PLANNING REPORT

TO: Conshohocken Borough Planning Commission
RE: 239 – 301 West Fourth Avenue
Preliminary/Final Minor Subdivision and Land Development
PZ#: 2013-11
DATE: 18 February 2014

Zoning Review: 239 – 301 West 4th Avenue, Conshohocken, PA 19428

ZONING ENFORCEMENT NOTICE

SITE ADDRESS: 301 W. 4TH AVENUE
FINAL AS-BUILT
LOT 1 & 2
CARDAMONE TRACT
Situate In:
The Borough of Conshohocken
Montgomery County, Pennsylvania

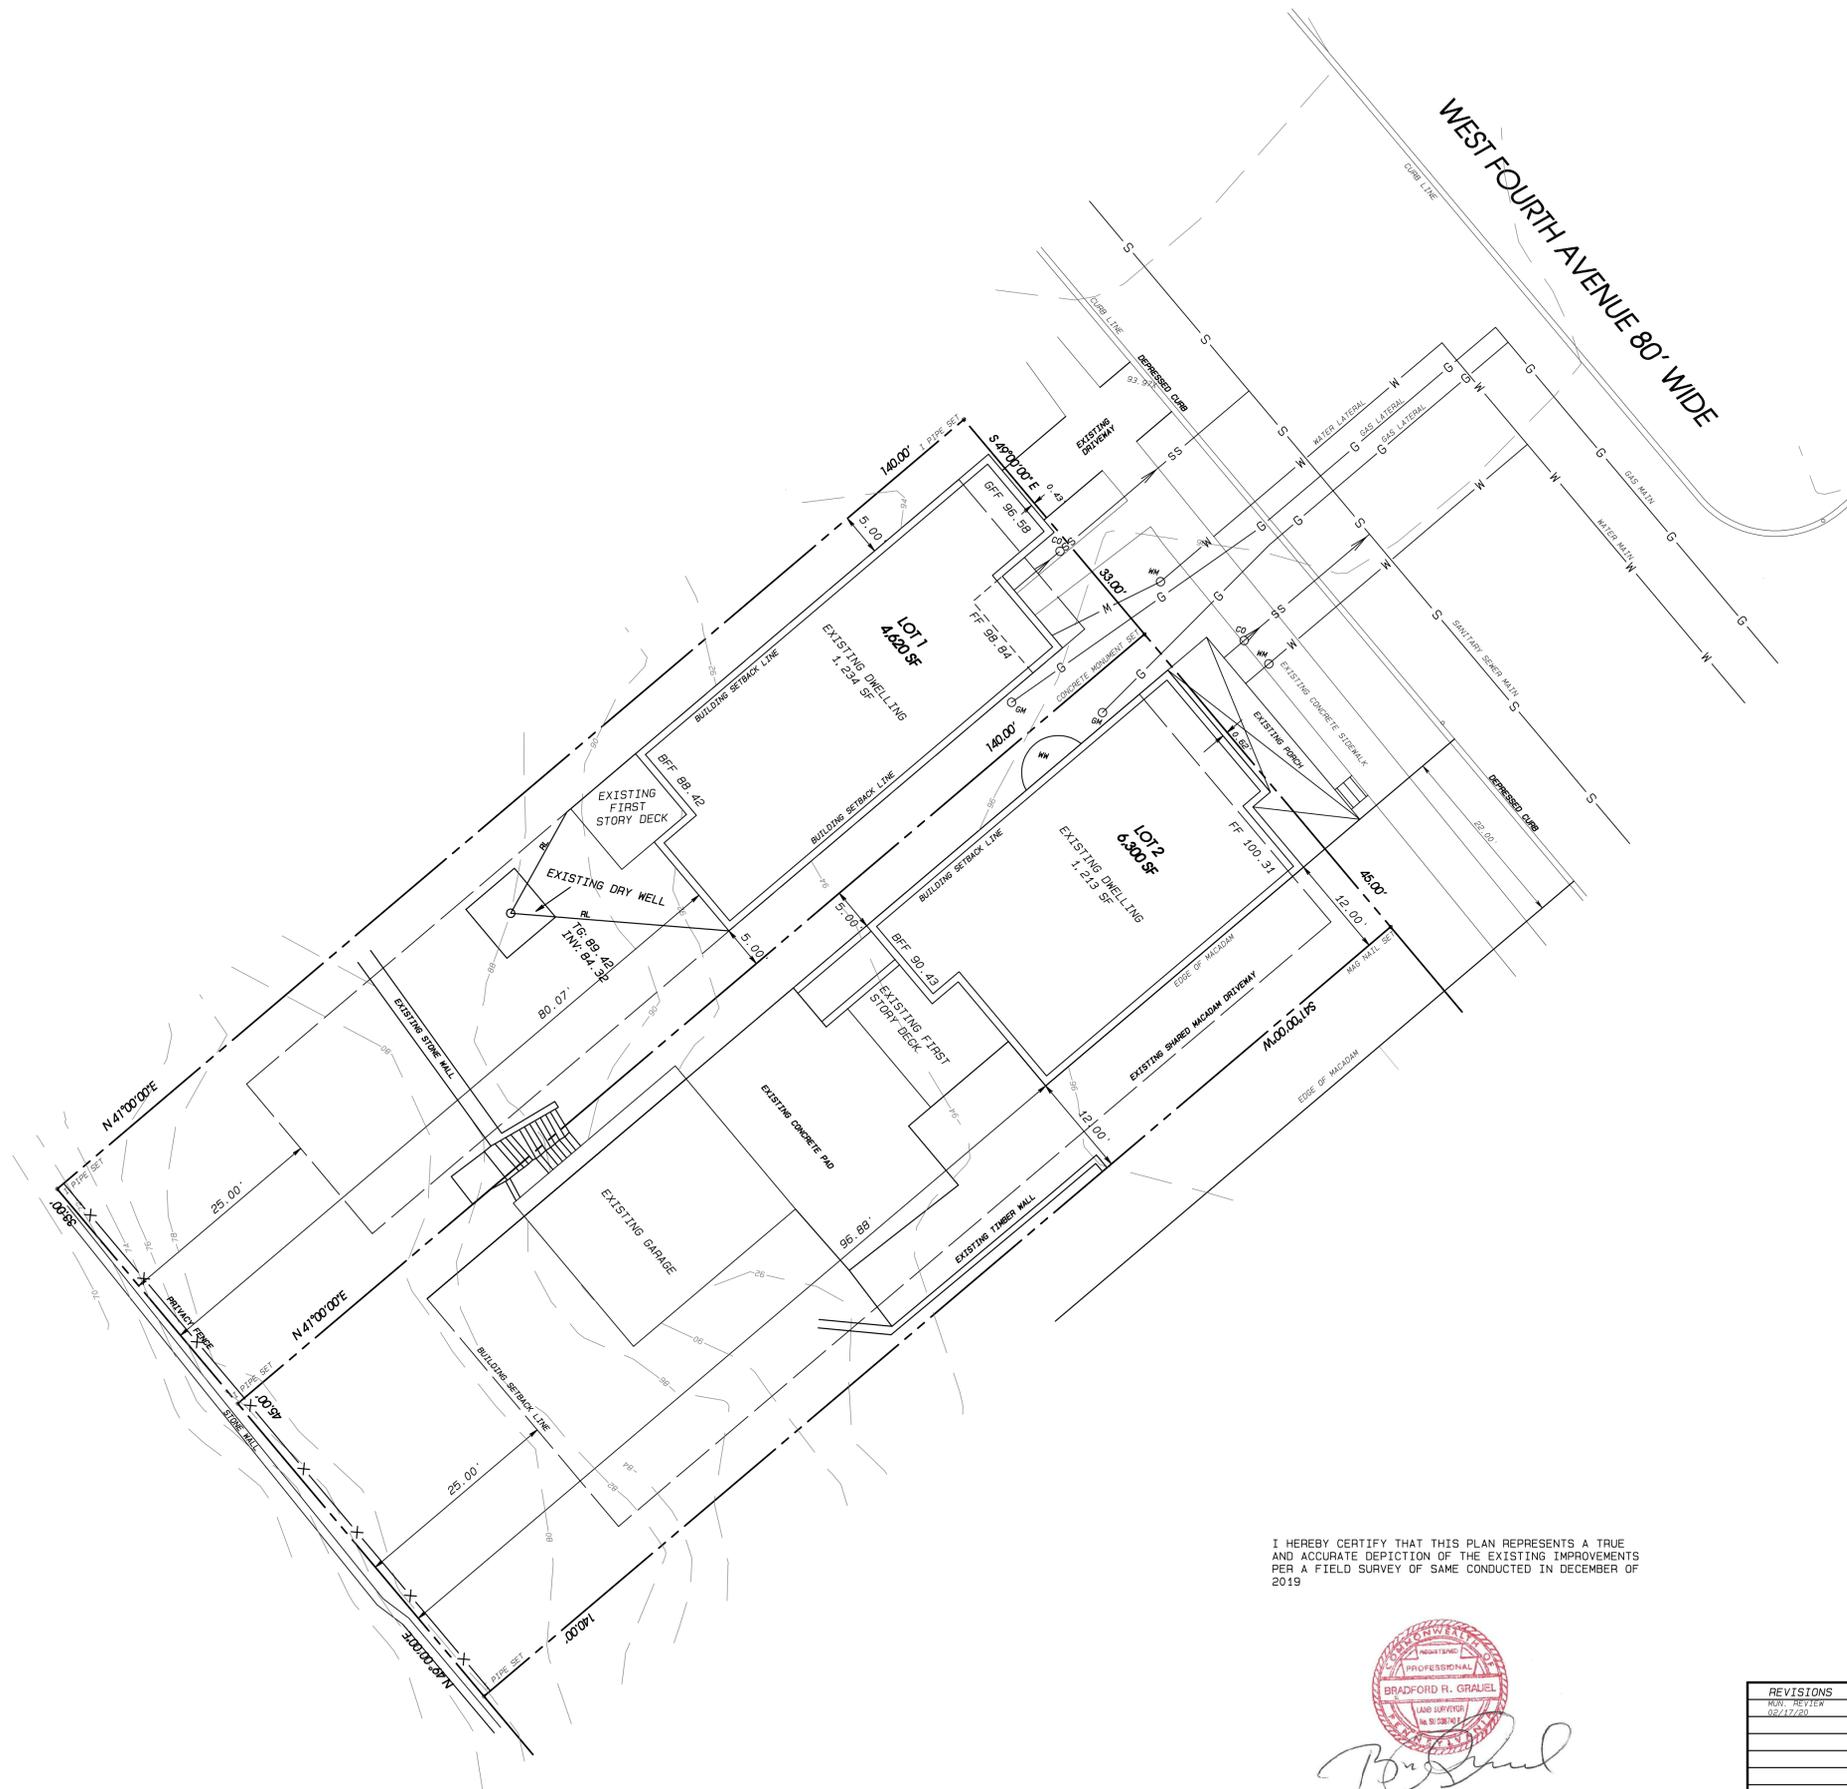
Per the recently submitted plan titled "*Final As-Built Lot 1 & 2 Cardamone Tract*," (1 sheet) prepared by OTM, LLC, last revised February 17, 2020, it appears that your use of the above-described property is in violation of the Conshohocken Borough Zoning Ordinance of 2001 as amended December, 2005 as specified below:

Per the approved Land Development Record Plan for the referenced property, the front yard setback for the newly constructed residential dwellings is required to be 5 feet, measured from the ultimate right-of-way line of West 4th Avenue. The referenced As-Built plan indicates a front yard setback of 0.43 feet on Lot 1 and 0.62 feet on Lot 2.

Before April 15, 2020, you must correct the referenced zoning violation or seek a variance from the Zoning Hearing Board.
